### **CASE FILE NUMBER: LU 12-200244 DZ**

*REVISIONS TO PREVIOUSLY APPROVED BUILDING (LU 11-160898 DZM)*

OHSU / OHSU COLLABORATIVE LIFE SCIENCES BUILDING  
 DESIGN REVIEW DRAWINGS OCTOBER 23, 2012

LEVEL 1 PLAN EXHIBIT C.33R

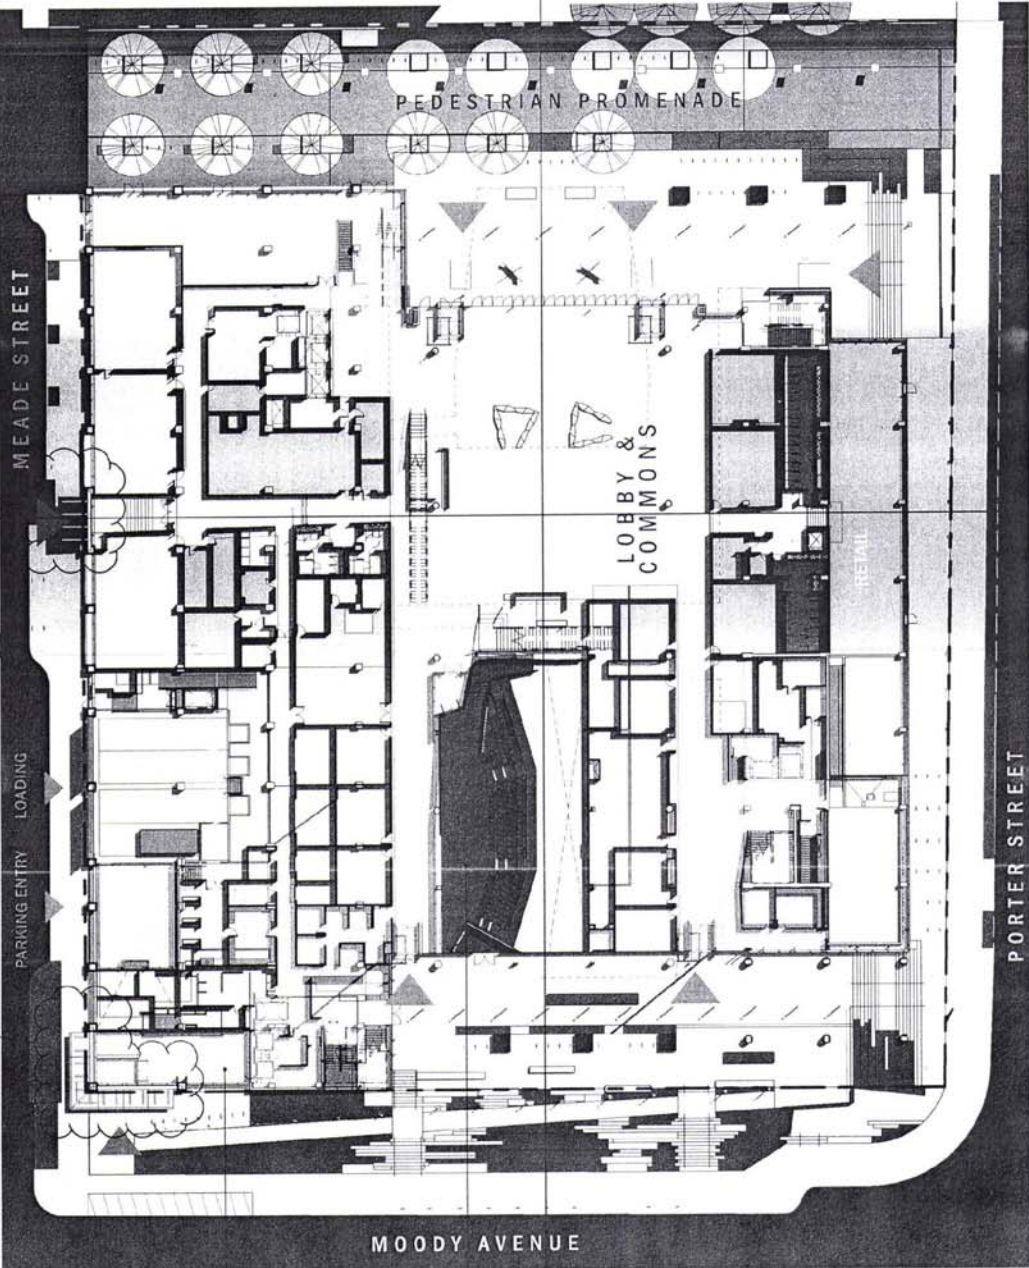
- A. Applicant's Submittal
  1. List of proposed changes
  2. Originally approved drawings
- B. Zoning Map (attached)
- C. Plans/Drawings:
  1. **C.33R** – North West canopy color changed from red glass to silver 1/8” thick aluminum metal panel. (attached)

CANOPY CHANGED TO 1/8" ALUMINUM SILVER METAL PANEL  
 CANOPY CHANGED TO 1/8" ALUMINUM RED METAL PANEL
